Building Manager: [Laura V. Shields, shieldla@oregonstate.edu](mailto:Laura.V.Shields,shieldla@oregonstate.edu)
 Assessment Date: 8/9/2022
 Assessment Number: **10594**
 Location: Adams Hall Entire
 Reinspection date:

A joint fire safety inspection of the facility listed above was performed by the Environmental Health & Safety - Fire and Life Safety and the Corvallis Fire Department. These fire safety deficiencies could result in a fire or jeopardize the safety of those occupying the facility. Please see that these items are corrected immediately and no later than the scheduled reinspection date noted with this report. If you have any questions regarding this inspection, please email Brian Lilley (EH&S - Fire and Life Safety) at brian.lilley@oregonstate.edu.

Basement Space 002

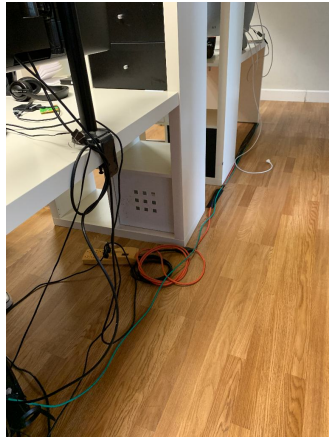
Priority code	Standard in need of attention	Reg.Reference	Location	Resp	Observations & Recommendations	Date Corrected
2	Discontinue use of extension cord not plugged directly into an approved receptacle. Do not chain together.	2019 OFC 604.5.1	002:inside	DEPT	Discontinue plugging extension cords into power strips and vice-versa. Replace with longer cord power strips to reach outlets.
